Application	X/23/94736
Please ask for	Liz Harrison
Direct dial	023 8068 8284
Working hours	
Email	liz.harrison@eastleigh.gov.uk

Application No:	X/23/94736
Description:	Variation of condition 1 (approved drawings) of reserved matters application RM/19/86658 (pursuant to outline planning permission O/15/75953, as amended by X/19/84943) for Boorley Gardens Phase 3 to allow revisions to the house types on plots 463-648 (with the exclusion of plots 569-577, 580, 583, 595-599 and 621-631).
Site:	Land North West of Winchester Road, Boorley Green, Hampshire, SO32 2BX

I am writing in response to the above application to vary the previously approved house types on some of the plots in Boorley Gardens phase 3. These comments should be read in conjunction with the consultation responses received from Landscape and Housing.

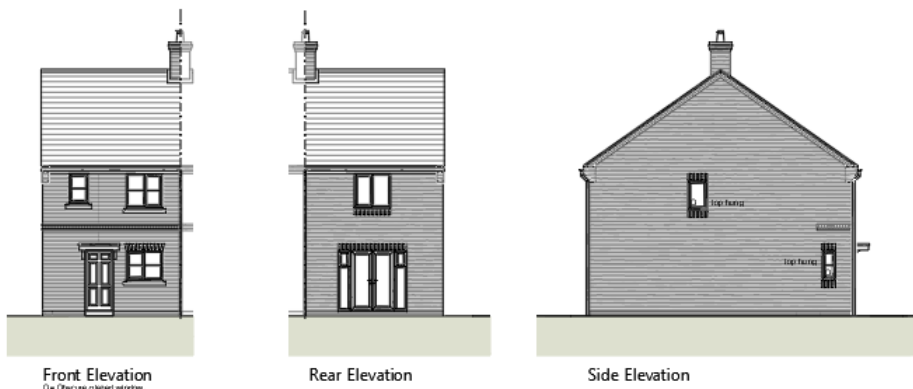
- The variety of house types on plots 511, 510, 509, 549, 548, 547, 546, 568, 567 is such that the streetscene these units form facing the western area of public open space – the first part of Streetscene 15 – is not cohesive and does not have a consistency in its character and appearance. As such amendments need to be made to these plots to provide more a better designed streetscene. Our

observation is that the only difference is the presence of more gables in our street elevation. The character and details are consistent. To address the concerns however we propose the following to reduce the gables: 511-Bowyer instead of Fuller, 509-Weaver instead of Fuller, 568 Weaver instead of Jewler, all reflected in revised layout and illustrated below as discussed at our meeting on 13 December 2023.

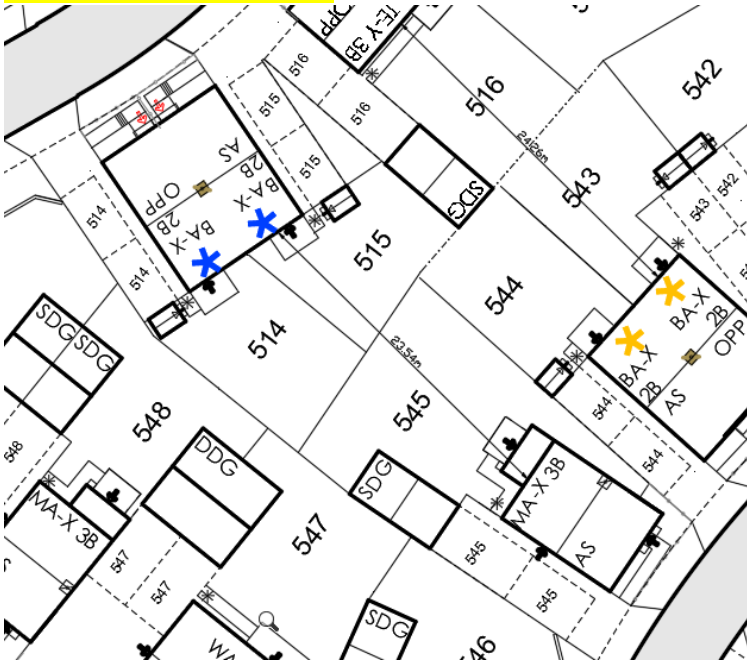
- The house type on plot 606 is not appropriate for this important corner plot as it does not satisfactorily address the road or the path to the side. In addition the use of the semi-detached properties on plots 606-607 and the resultant need for 3 sets of tandem parking spaces is not appropriate and this part of the layout needs to be reconsidered. This area has been adjusted to address comments as discussed and agreed at our meeting on 13 December 2023.

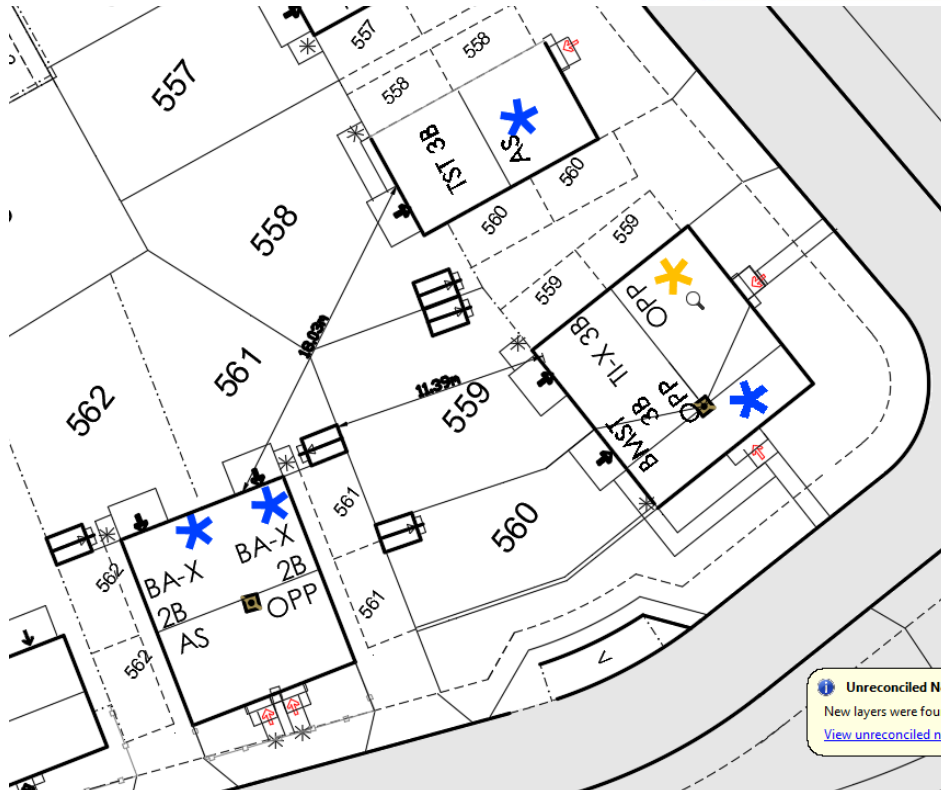
- **Plots 515 & 545** – the separation distance between the rear elevations of the 2 properties needs to be increased to a minimum of 23.5m due to the level difference. This has been revised as requested and discussed at our meeting on 13 December 2023.

- **Plots 516 & 543** – the separation distance between the rear elevations of the 2 properties needs to be increased to a minimum of 24m due to the level difference. This has been adjusted as requested and discussed at our meeting on 13 December 2023.

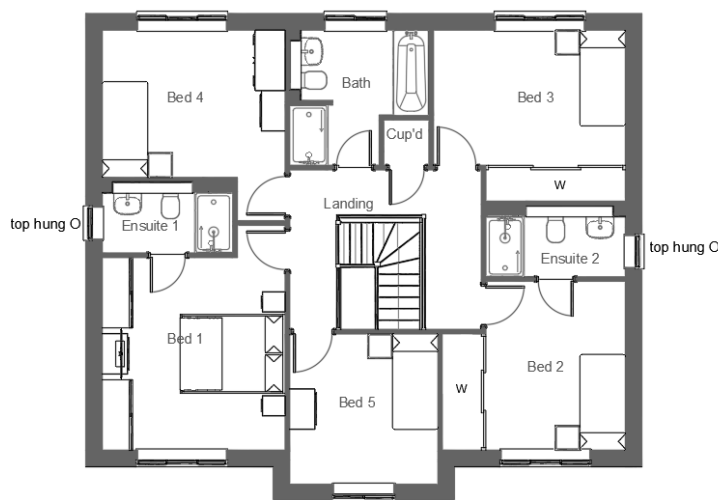
- **Plots 480, 496 & 499 (Watchmaker X House Type)** – the window serving ensuite 2 is annotated as being obscure glazed and fixed shut, but it is acceptable for it to be obscure glazed and top hung only to respect the neighbours' privacy but also allow for natural ventilation. This has been adjusted as discussed and agreed at our meeting on 13 December 2023.

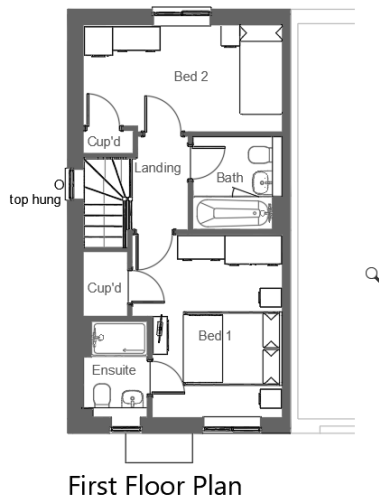
- **Plots 485, 579 & 584 (Cooper X House Type)** – the side window serving the stairs should be annotated as obscure glazed and top hung only on the floor plan, as it is on the elevations, to avoid undue loss of privacy for plot 484. This has been adjusted as discussed and agreed at our meeting on 13 December 2023.

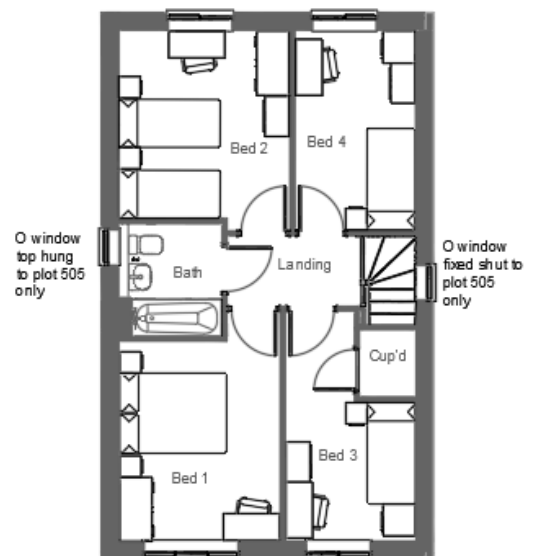
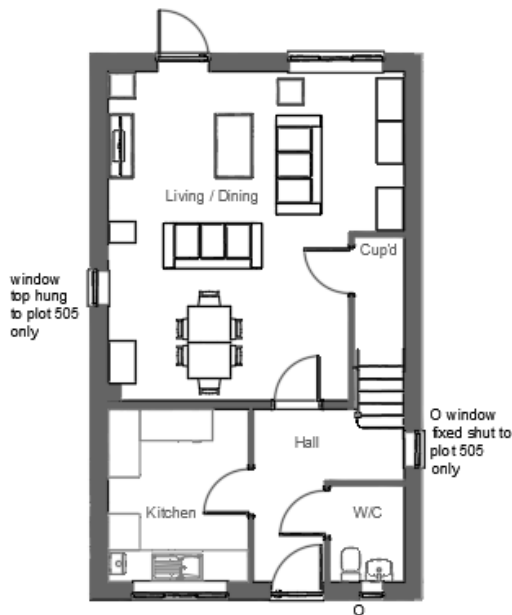
- Plot 505 (Cartographer X House Type)** – the side window serving the stairs should be annotated as obscure glazed and top hung only to avoid undue loss of privacy for plot 504. In addition the window serving the bathroom is annotated as being obscure glazed and fixed shut, but it is acceptable for it to be obscure glazed and top hung only to respect the neighbours' privacy but also allow for natural ventilation. This has been handed as per the second letter (dated 23/11/23) request, stairs window fixed shut as located on property boundary.

First Floor Plan
O= Obscure glazed window.

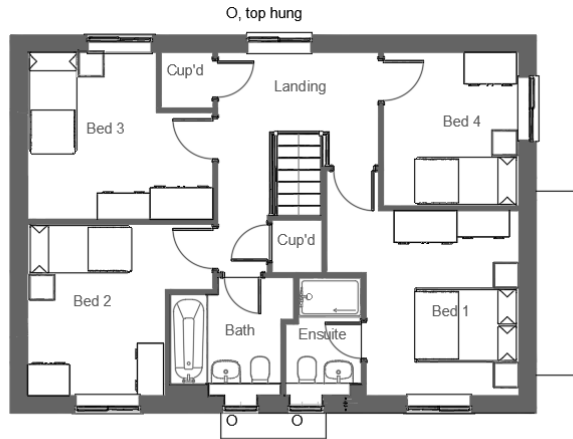
- **Plot 529 (Bowyer House Type)** – the rear landing window should be annotated on the elevations and floor plans as obscure glazed with any opening parts being top hung only to ensure no undue loss of privacy for plot 526. This has been adjusted as requested and discussed at our meeting on 13 December 2023.

Side Elevation
O= Obscure glazed window.

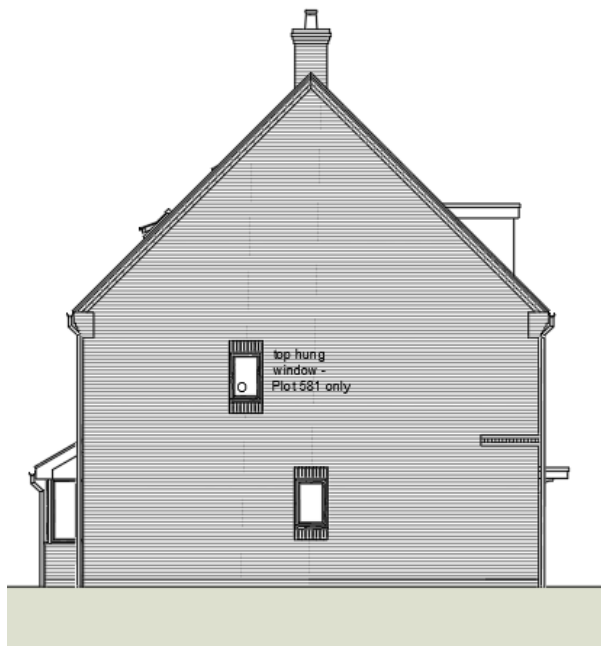
- **Plot 581 (Spinner X House Type)** – the side bathroom window should be annotated as obscure glazed and top hung only to avoid undue loss of privacy for plot 580. This has been adjusted as discussed and agreed at our meeting on 13 December 2023.
